Addendum 66: Regulation No. 67

Revision 1 - Amendment 3

Supplement 3 to the 01 series of amendments - Date of entry into force: 13 November 2004

- I. APPROVAL OF SPECIFIC EQUIPMENT OF MOTOR VEHICLES
USING LIQUEFIED PETROLEUM GASES IN THEIR PROPULSION SYSTEM**
- II. APPROVAL OF A VEHICLE FITTED WITH SPECIFIC EQUIPMENT
FOR THE USE OF LIQUEFIED PETROLEUM GASES IN ITS PROPULSION
SYSTEM WITH REGARD TO THE INSTALLATION OF SUCH EQUIPMENT**

Figure 3: Connecting area of the light vehicle Euro filling unit"

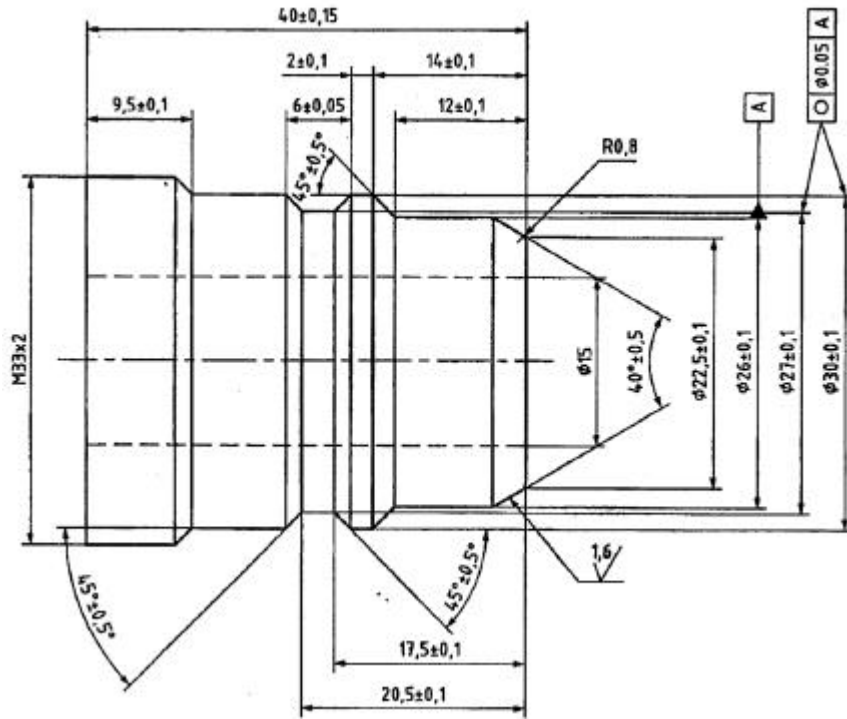
"6.15.10.6. Specific provisions regarding the light vehicle Euro filling unit (Annex 9 – Figure 3):

6.15.10.6.1. The dead volume between the front sealing surface and the front of the non-return valve shall not exceed 0.1 cm³;

6.15.10.6.2. The flow through the connector at a pressure difference of 300 kPa shall be at least 60 litres/min, if tested with water.

Insert a new Figure 3, to read:

Figure 5: Connecting area of the heavy-duty vehicle Euro filling unit"

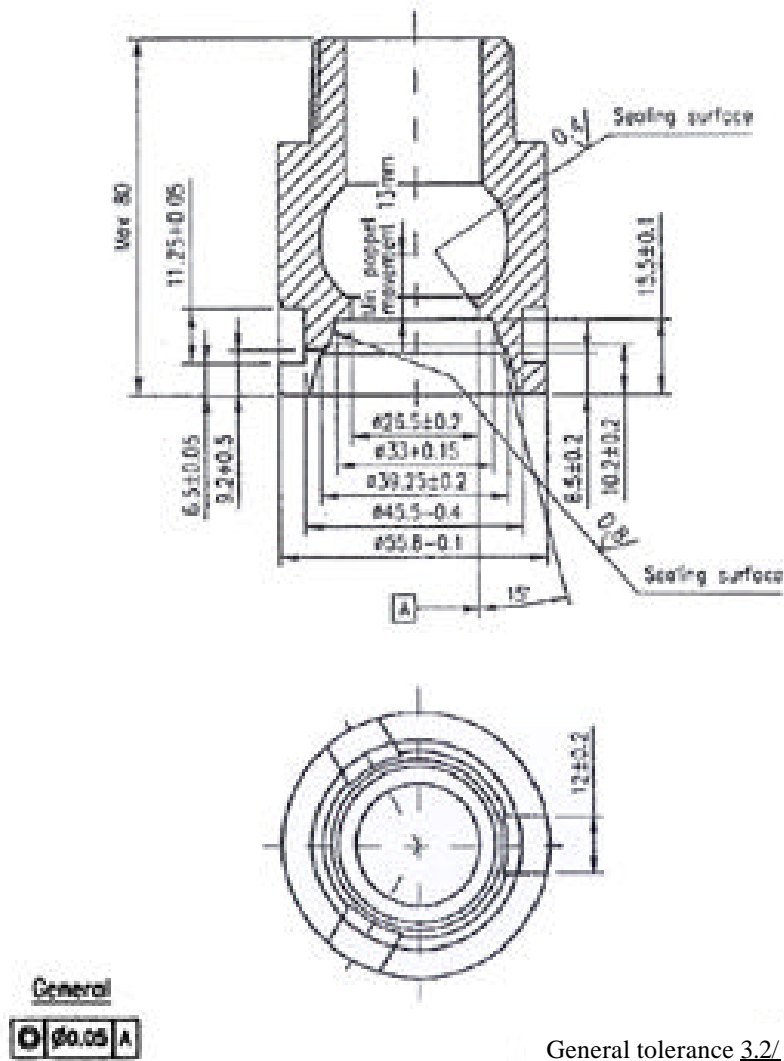
6.15.10.7. Specific provisions regarding the heavy-duty vehicle Euro filling unit (Annex 9 – Figure 5):

6.15.10.7.1. The dead volume between the front sealing surface and the front of the non-return valve shall not exceed 0.5 cm³;

6.15.10.7.2. The flow through the filling unit, with the non-return valve mechanically opened, at a pressure difference of 500 kPa shall be at least 200 litres/min, when tested with water."

Insert a new Figure 5, to read:
